HISTORIC AND DESIGN REVIEW COMMISSION

HDRC CASE NO:	2022-177
ADDRESS:	909 HAYS ST
LEGAL DESCRIPTION:	NCB 1654 BLK B LOT 11
ZONING:	R-5, H
CITY COUNCIL DIST.:	2
DISTRICT:	Dignowity Hill Historic District
APPLICANT:	Frank Telles/FT Builder Services LLC
OWNER:	Brian King/MARTINEZ VIOLA OVALLE
TYPE OF WORK:	Construction of a rear addition, exterior modifications, rehabilitation
APPLICATION RECEIVED:	March 22, 2022
60-DAY REVIEW:	Not applicable due to City Council Emergency Orders
CASE MANAGER:	Edward Hall

REQUEST:

PROPOSED ROOF PLAN

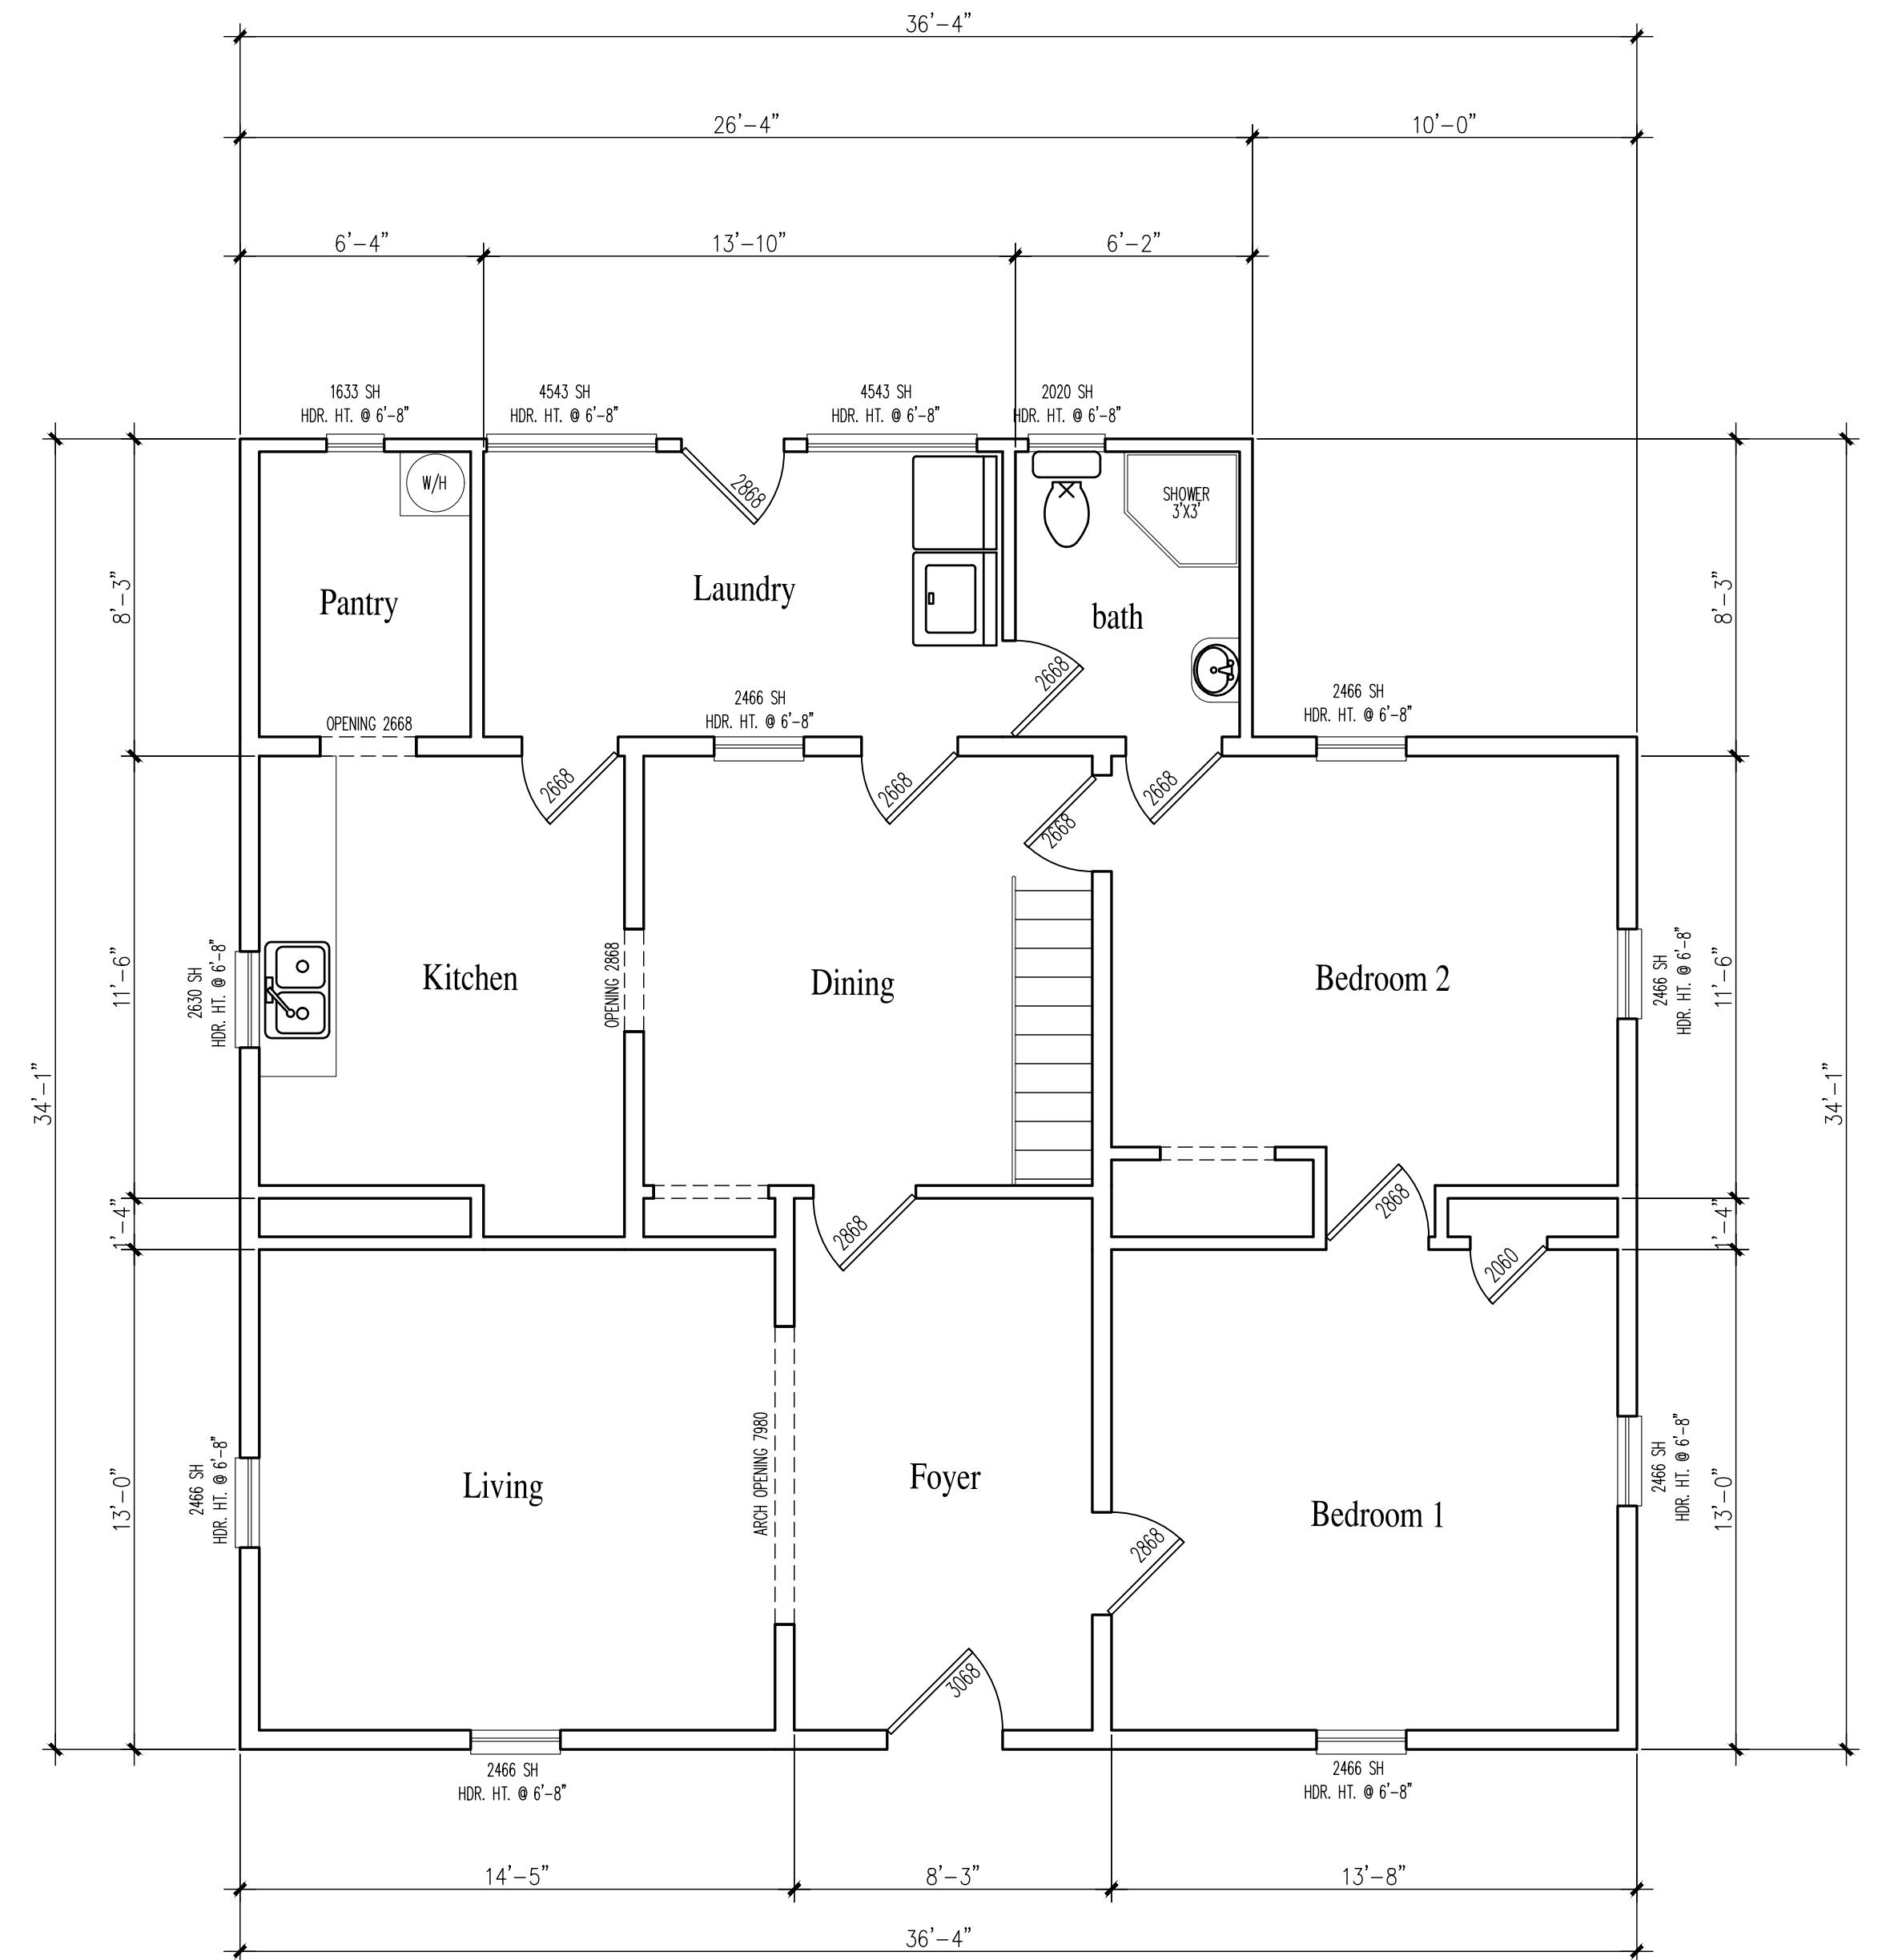
- d. REAR DORMER REMOVAL – The applicant has proposed to construct a rear addition which will result in the removal of an existing, rear roof dormer. The dormer currently features a ridge height that is higher than that proposed. The Guidelines for Exterior Maintenance and Alteration 3.B.iii., original roof features, including dormers should be preserved. Generally, staff finds that the applicant should explore ways to maintain the dormer or incorporate the dormer's ridgeline into that of the proposed addition.

- j. ROOF FORM – The applicant has proposed for the rear addition to feature a hipped roof featuring a 5/12 slope. The Guidelines for Additions 2.A.iii., roof forms should utilize similar roof pitch, form, and orientation as the principal structure for additions, particularly for those that are visible from the public right-of-way. As noted in finding d, staff finds that the applicant should explore ways to maintain the existing, rear dormer or to incorporate the dormer's ridgeline into that of the proposed addition. Additionally, staff finds that the addition's roof slope should match that of the historic structure's roof slope.

3. Staff does not recommend approval of item #3, the removal of the rear roof dormer based on finding d. Staff recommends that the applicant explore ways to maintain the dormer or incorporate the dormer's ridgeline into that of the proposed addition.

909 Hays
San Antonio TX 78202
PROPOSED FLOOR PLAN

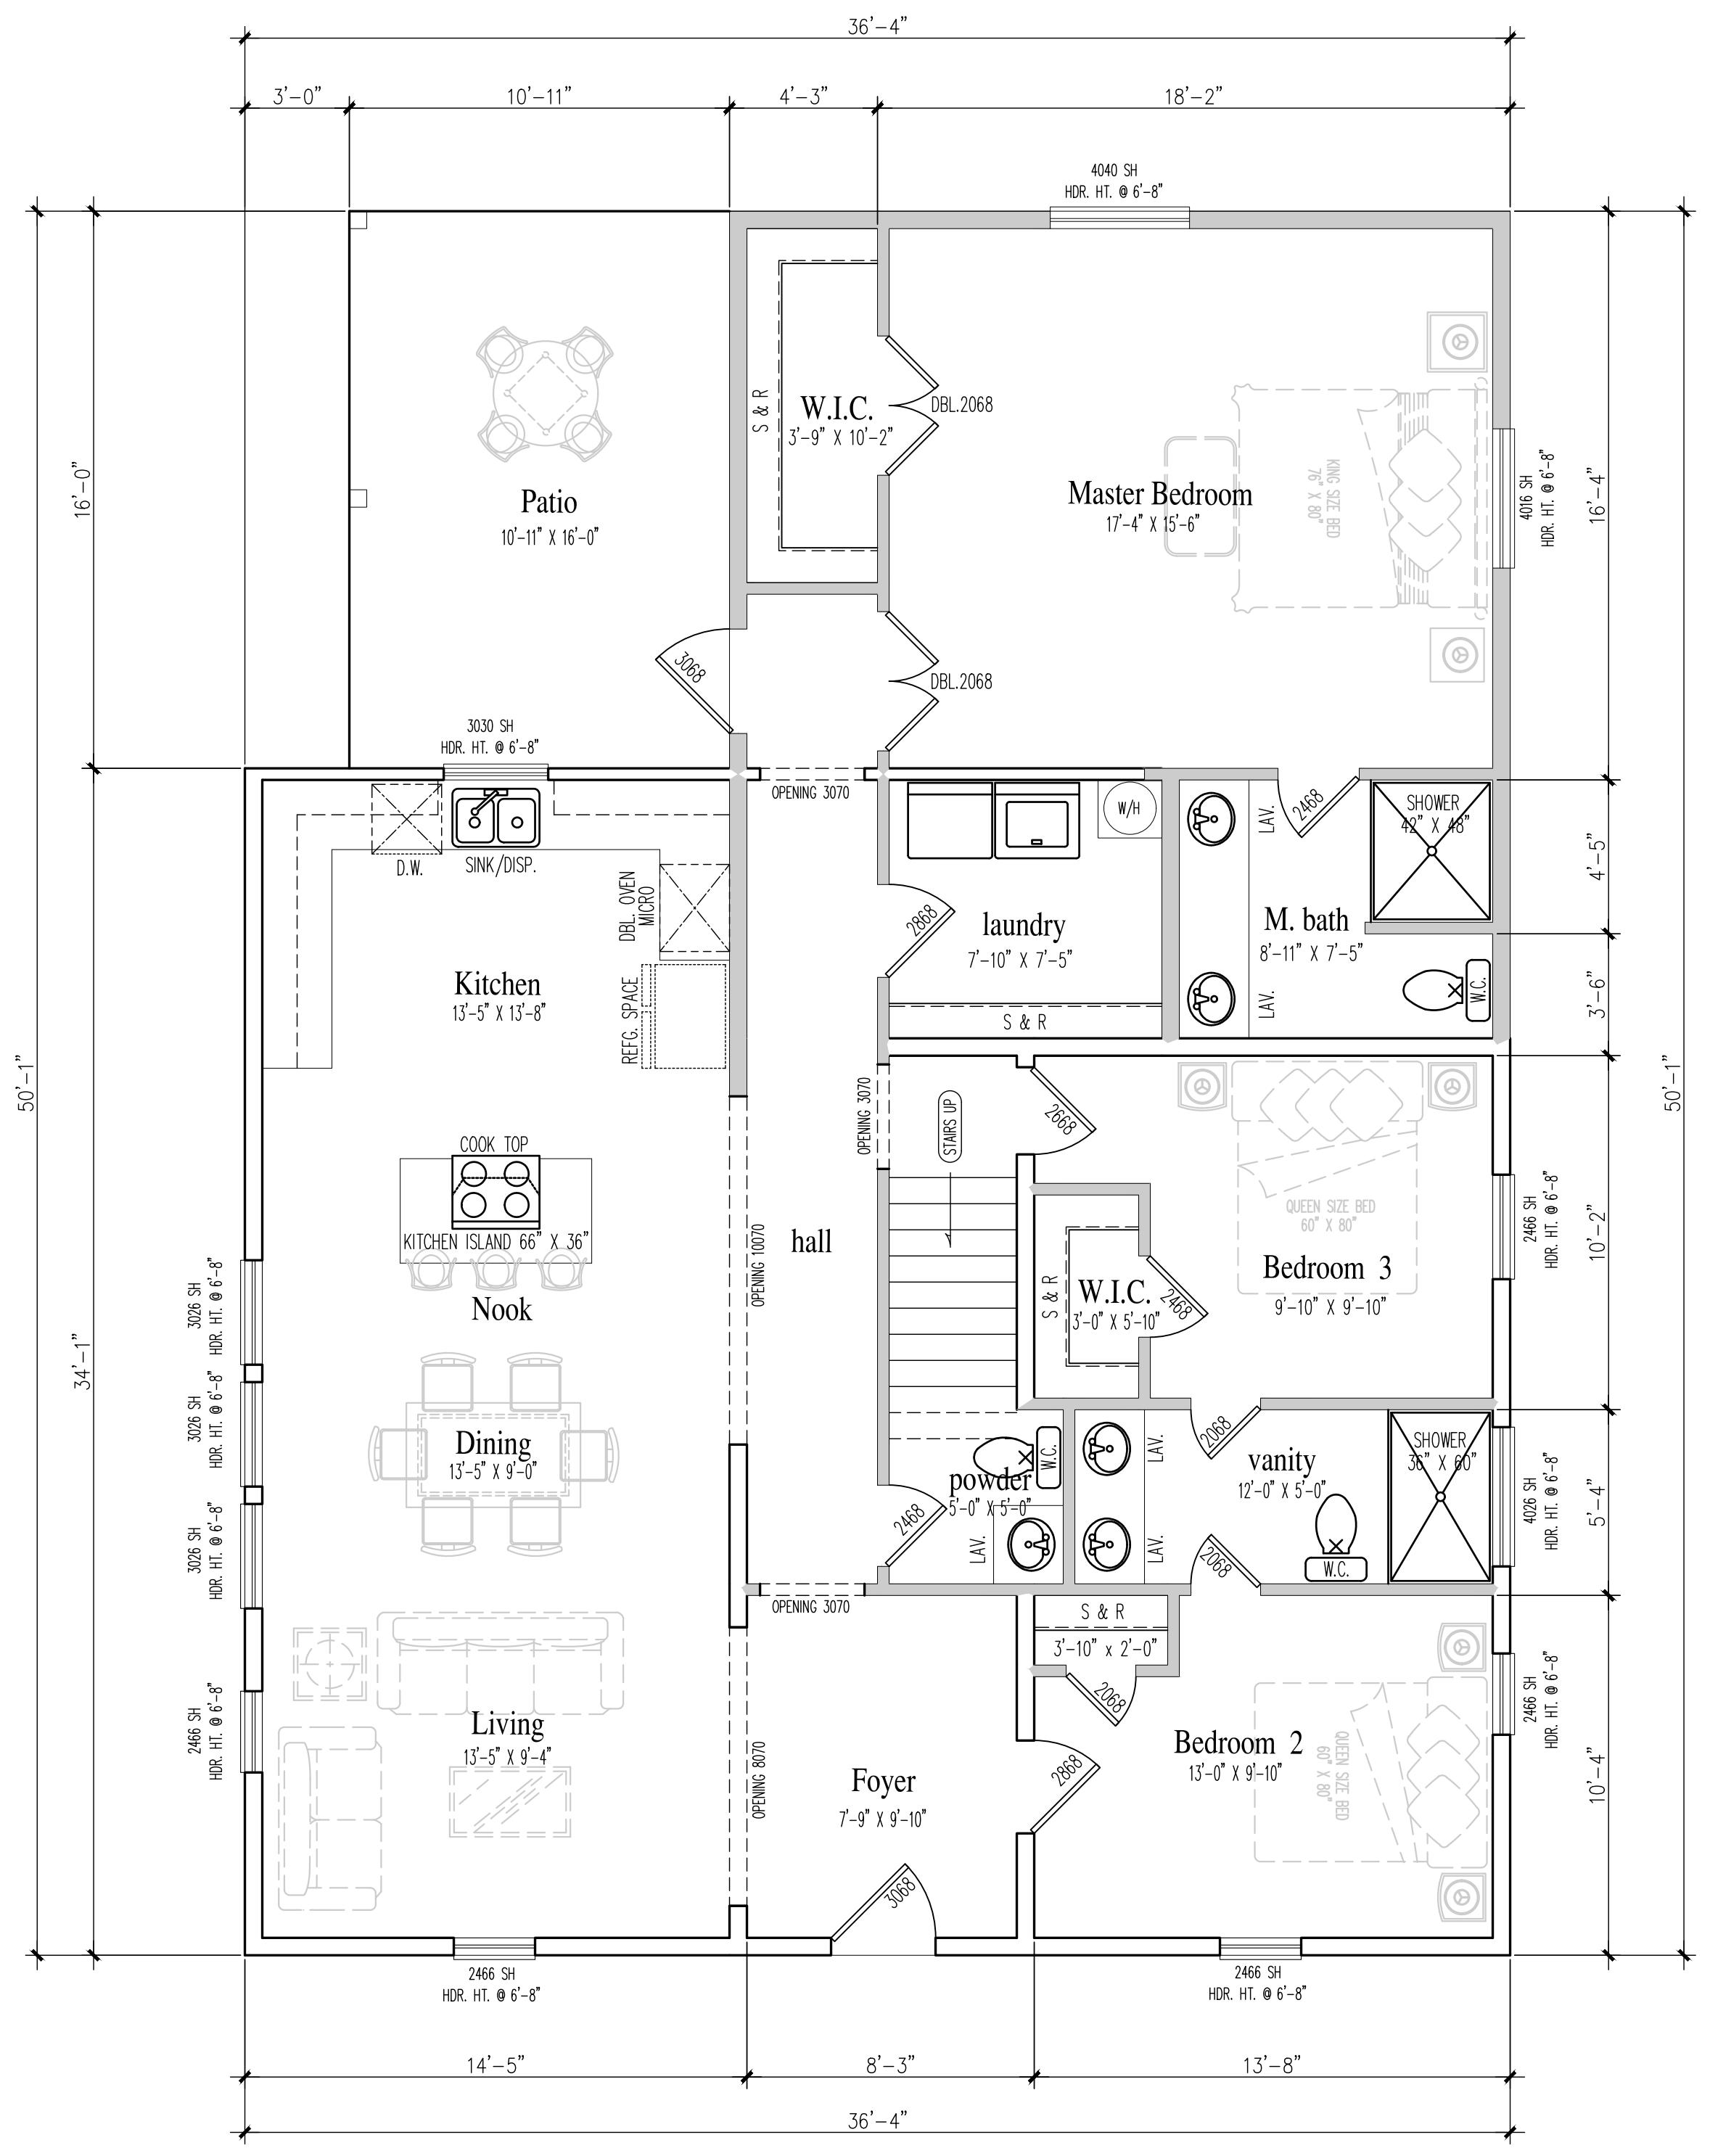
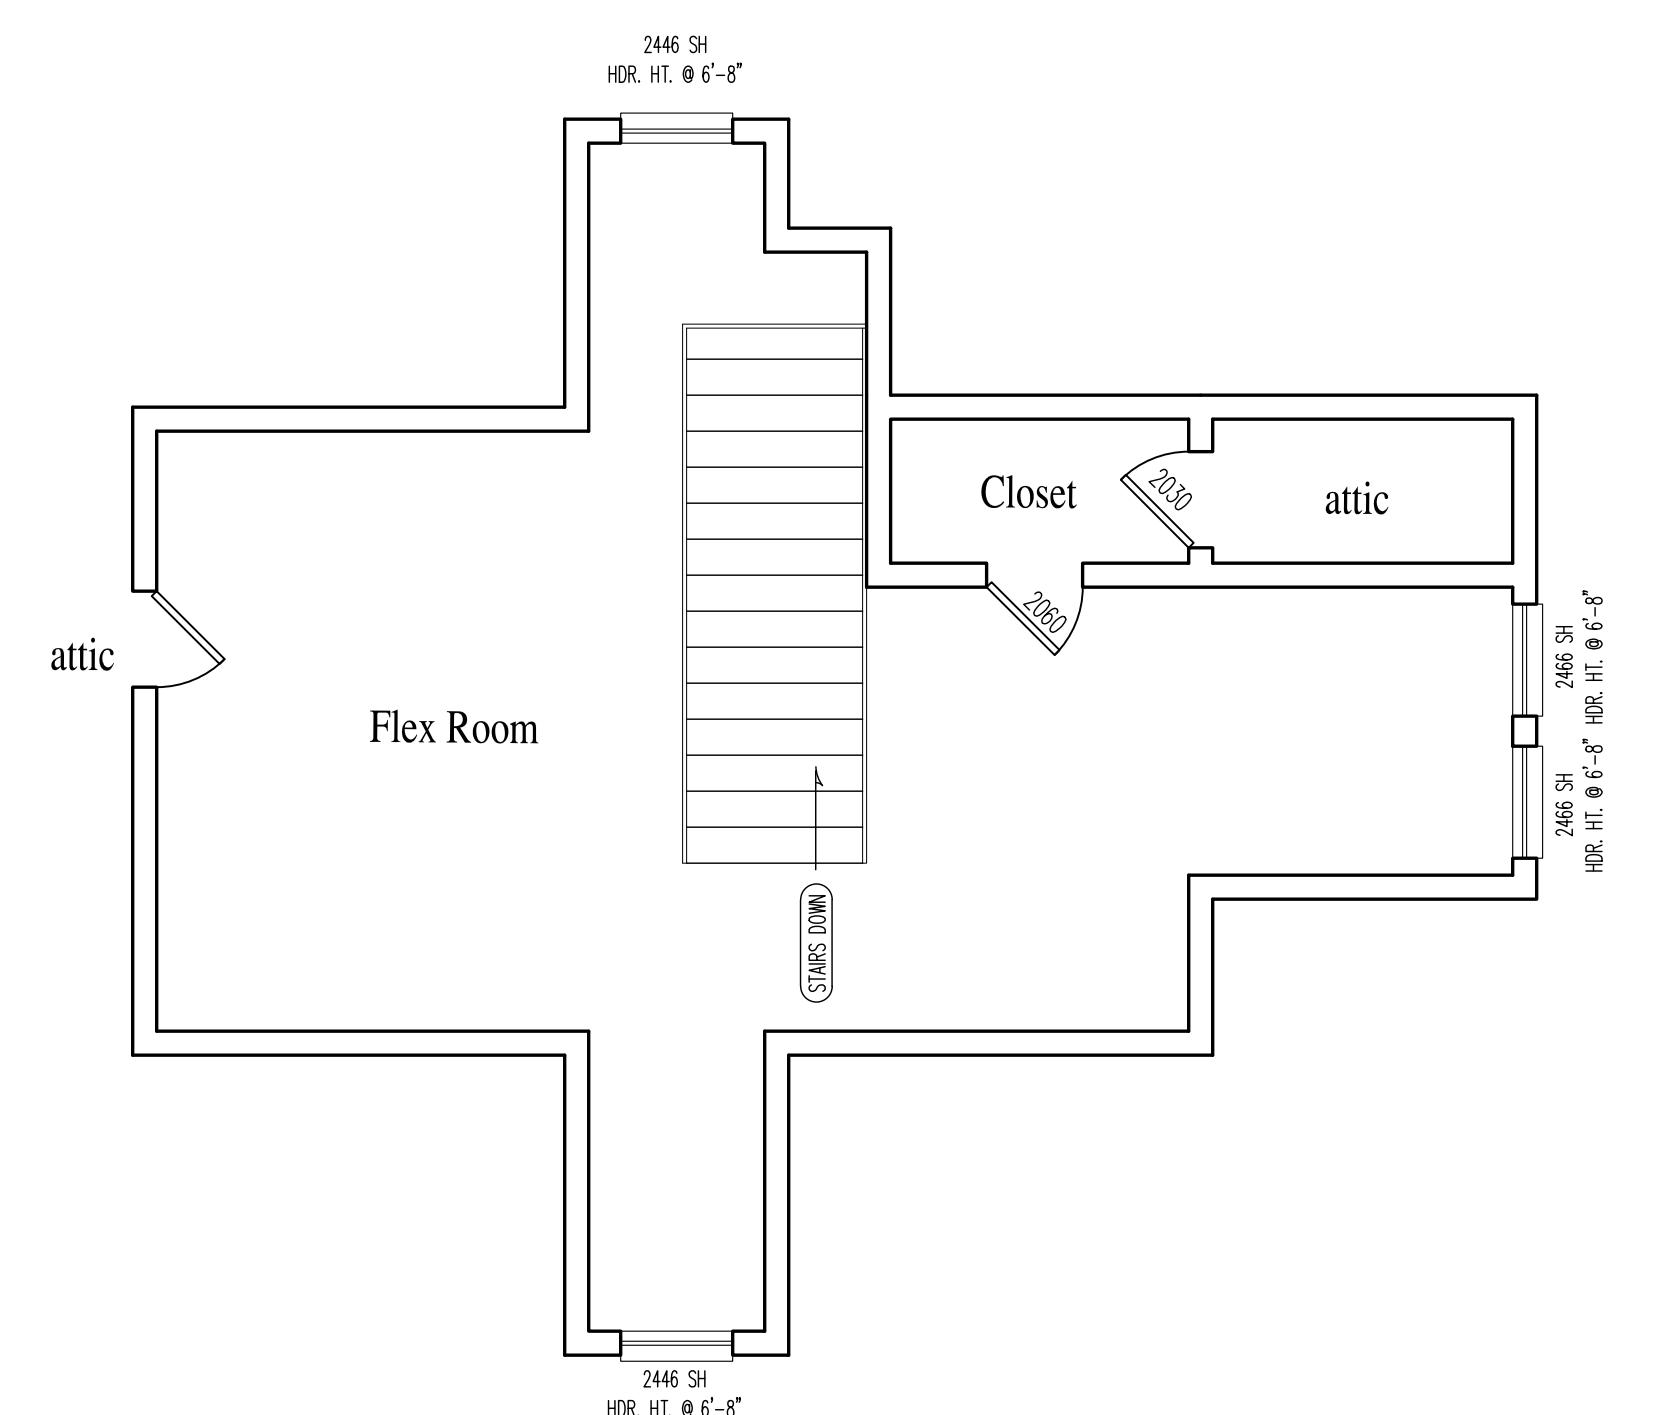
- c. FENESTRATION MODIFICATIONS – The applicant has proposed to perform fenestration modifications on both the east and west façades by creating new window openings and modifying existing window openings. The proposed new window openings feature contemporary sizes and profiles. The Guidelines for Exterior Maintenance 6.A.i. notes that exterior window and door openings should be preserved. Staff finds that the existing window openings should be preserved in their current location and that their original profile should be maintained. Additionally, the Guidelines note that new window openings should not be created on primary facades or where visible from the right of way. Staff finds the proposed modifications to the existing window openings as well as the creation of new window openings on the side facades to be inconsistent with the Guidelines.

- block, should feature similar roof forms, and should feature a transition to differentiate the new addition from the historic structure. Additionally, the Guidelines for Additions 1.B notes that additions should be subordinate to the principal façade of the historic structure, should feature a footprint that responds to the size of the lot, and should feature an overall height that is generally consistent with that of the historic structure. Generally, staff finds the proposed addition to be appropriate; however, staff finds that either a setback or vertical trim piece should be added to the east façade to differentiate the addition from the historic structure.

- i. WINDOW PROFILES – The applicant has proposed for the rear addition to feature windows on the rear addition that feature contemporary profiles. Staff finds that windows that are consistent with the profile of those found on the historic structure should be installed. Additionally, staff finds that additional fenestration should be added to the rear addition.

1. Staff recommends approval of item #1, window repair, based on finding b with the stipulation that windows are repaired in-kind.
2. Staff does not recommend approval of item #2, fenestration modifications to the east and west facades based on finding c. Staff recommends that original window openings be maintained and that no new window openings be created within the historic structure's footprint. Evidence for previously enclosed windows may be presented to OHP staff for rehabilitation.

4. Staff recommends approval of item #4, the construction of a rear addition based on findings e through l with the following stipulations:
 - i. That either a setback or vertical trim piece be added to the east façade to differentiate the addition from the historic structure.

- iii. That wood or aluminum clad wood windows be installed that are consistent with staff's standards for windows in new construction and additions.
 - iv. That the addition feature window profiles that are consistent with those of the historic structure and that additional fenestration be added to the rear addition.
 - v. That the applicant explore ways to maintain the existing, rear dormer or to incorporate the dormer's ridgeline into that of the proposed addition. Additionally, staff recommends that the addition's roof slope match that of the historic structure's roof slope.
5. Staff recommends approval of item #5, driveway, curb cut and apron modifications with the stipulation that the driveway not feature more than ten (10) feet in width, and that the existing curb cut and apron be maintained.
